TOWN OF HUDSON

Conservation Commission

2 February 2014

Subject: Environmental Issues Regarding the Conceptual Circumferential Roadway

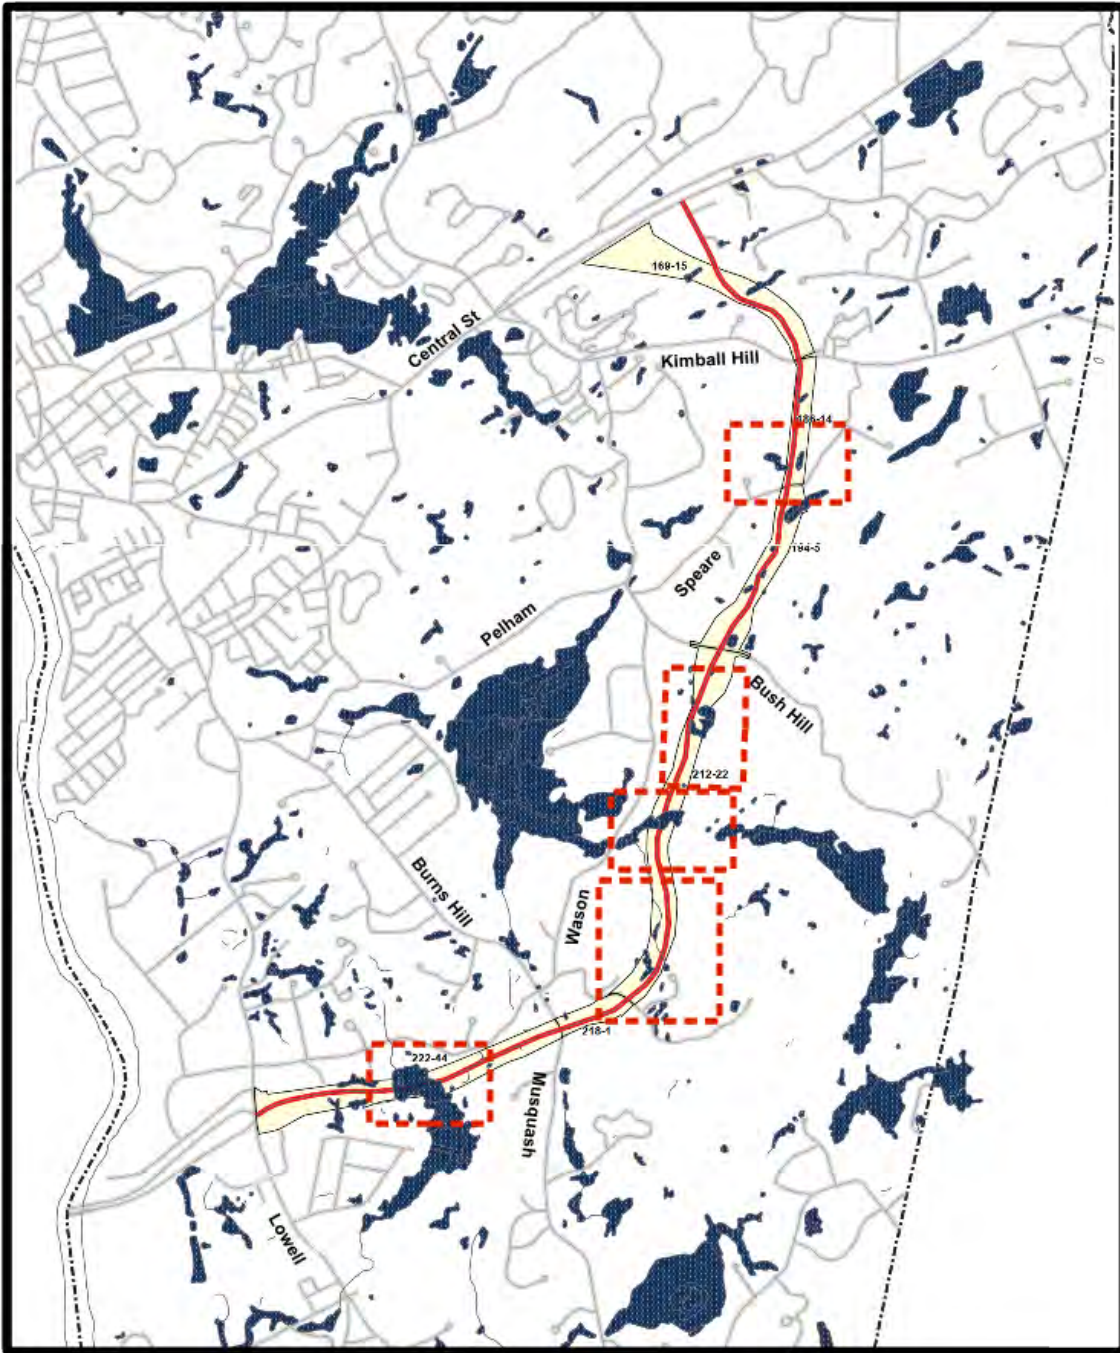
2. The conceptual roadway layout was restricted to the existing Nashua-Hudson Circumferential Highway (NHCH) right-of-way. The route was selected to minimize wetland impacts based on existing GIS mapping and aerial photography available to the NRPC (Attachment 1). This concept assumed that reducing the width of the roadway to two lanes, in contrast to the proposed multilane NHCH highway, many of the adverse environmental effects that resulted in the cancellation of the NHCH project could be reduced or avoided.

9. The Commission noted that news reports, particularly the Hudson-Litchfield News (18 October 2013), suggest the possible reconsideration of the full four lane design of the HNCH. In that event, we believe that the proposed roadway would face the same issues as the original NHCH and would require significant rerouting outside the existing corridor particularly in the southern half of the route. This situation is clearly echoed in the New Hampshire Department of Transportation NHCH routing map accompanying the Hudson Litchfield News article of 18 October 2013 (Attachment 5).

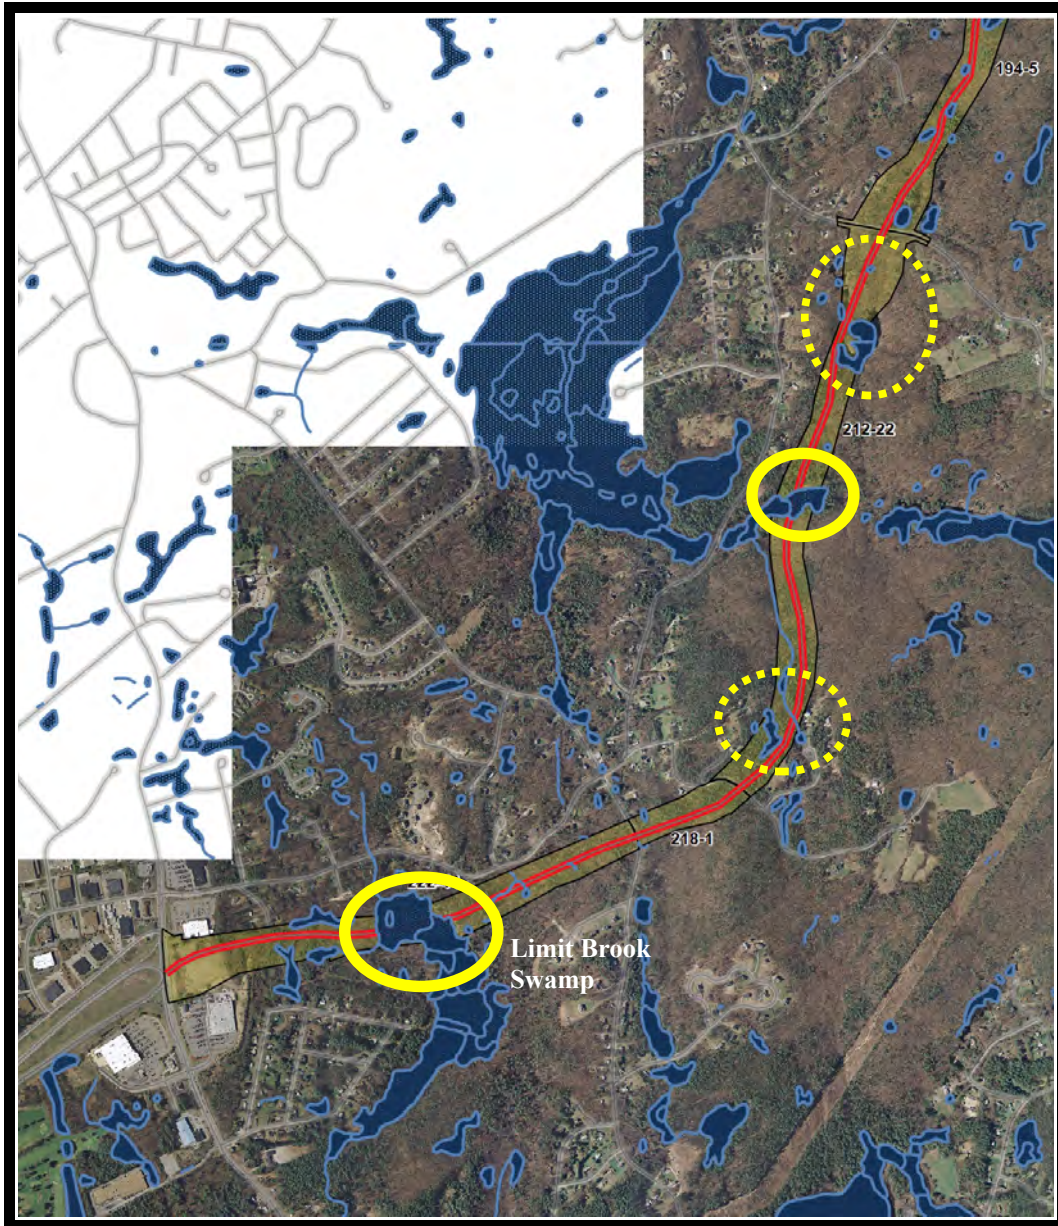
5. Of particular note are the proposed crossings of Limit Brook Swamp and Miles Swamp (Attachment 2) both of which were identified as having significant functional value during the Prime Wetlands Assessment conducted in 2008 for the Hudson Conservation Commission. This evaluation was made using a scientifically defensible process know as the *Method for Comparative Evaluation of Nontidal Wetlands in New Hampshire* (Ammann and Stone, 1991). These two wetlands had functionality rated as in the upper half of the 28 major Hudson wetlands examined in this study.

Wetland Crossing #1 – Limit Brook Swamp:

Wetland Crossing #2 – Second Brook:

Attachment 3 – Topographic contours underlying the conceptual route of a circumferential roadway (red line) highlighting (red ovals) several areas which might require terrain alteration during construction that could have potential impacts on wetlands and streams.

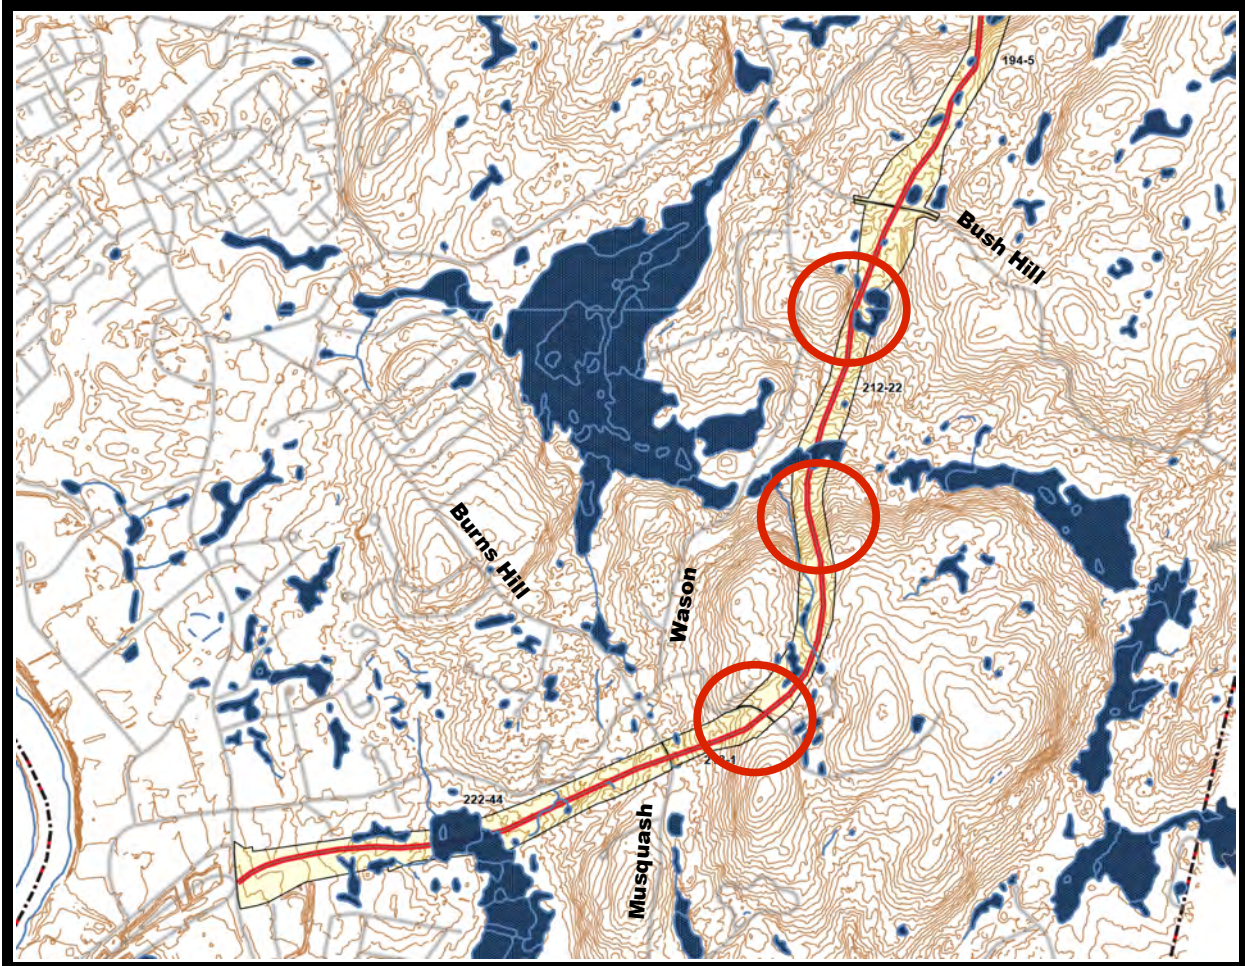
6. The Commission noted several areas of steep slopes in this segment of the right-of-way

whose modification for roadway construction would result in alteration of terrain also likely to produce adverse drainage and wetland impacts (Attachment 3).

During the HCC site walks conducted in 2012-2013, there was a general consensus of concern that several areas of the proposed roadway corridor have steep gradients. Extensive modification of these slopes has the potential to significantly impact drainage patterns into the adjacent wetlands and waterways. Any roadway design will require extensive engineered systems to handle the impact of roadway runoff and its related contaminants. Infiltration basins and other appropriate BMP's will be required extensively throughout the corridor to maintain existing water quality. Therefore, several areas of the corridor will require extensive development (blasting, grading, etc.) of the corridor itself and potentially to adjacent properties as well. Our current documentation is limited, however it is intended that the Commission will further monitor these areas, as plans for the corridor are further developed.

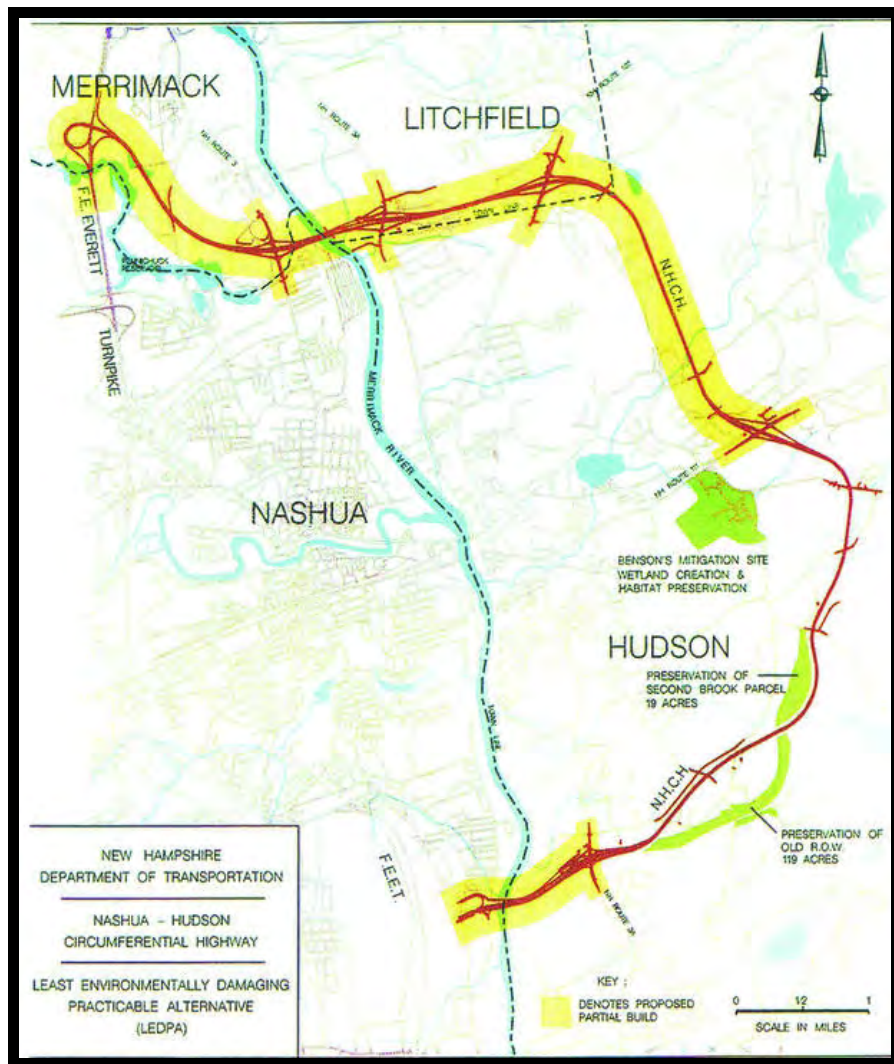
7. Of concern for the proposed routing is the fact that the existing mapped wetlands throughout the corridor is deficient and does not accurately represent the on-the-ground situation. This possibility is acknowledged in the CTAP Report. One significant example of this mapping deficiency and its possible effect on design can be seen at a wetland pocket located in the corridor to the north of Speare Road is illustrated in Attachment 4. Minor impact is suggested by the CTAP Report but ground recognizance suggests a more significant effect. Obviously, in this case and others, further study by certified wetland scientists is required.
